Errata: CS43L43 Revision GCS43L43 Low Voltage, Stereo DAC with Headphone Amp

All references to the CS43L43 mentioned below shall be taken to refer to revision G of the CS43L43 product. The hardware revision code can be found in the 7-character field printed below the part number on each chip. The letter which appears as the fifth character from the right is the revision code (e.g. OCG0046 is a Revision G part).

Figure 1. Optional Headphone Mute Circuit for Revision G

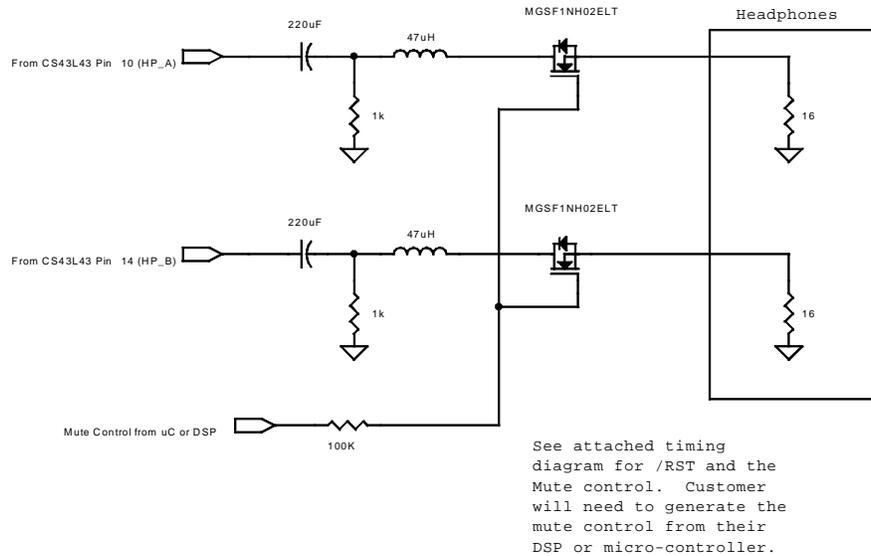
- For critical applications, the PopGuard[®] Transient Control may not be sufficient in eliminating extraneous audible artifacts on the headphone outputs during power-up. For these applications, an optional external mute can be used to maintain an absolute minimum of extraneous clicks and pops. Please see Figures 1 and 2 for the headphone mute circuit.
- The headphone outputs clip when the value of VA_HP is below VA. It is recommended that these two supplies be tied together.
- When the Analog Headphone Attenuation Control registers (02h and 03h) are set for attenuation levels greater than -10 dB, the actual attenuation deviates from the register setting by more than 1 dB.

The Motorola MOSFETs shown have been tested to work properly, however, an equivalent device may be used.
